THIS REPLACEMENT ROTOR MAY HAVE A DIFFERENT APPEARANCE FROM THE ORIGINAL FACTORY ROTOR.

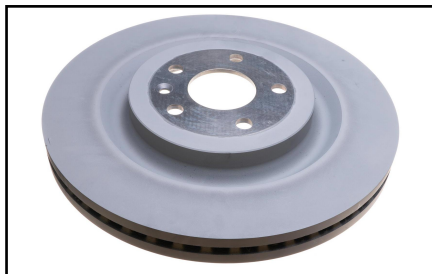
The original factory design incorporated a vented hat
(Ford OE# DG1Z1125B, DG1Z1125C)

Ford has superseded this with a solid hat design
(Ford OE# GG1Z1125A)

**FITMENT AND INSTALLATION ARE NOT
AFFECTED BY THIS CHANGE.**
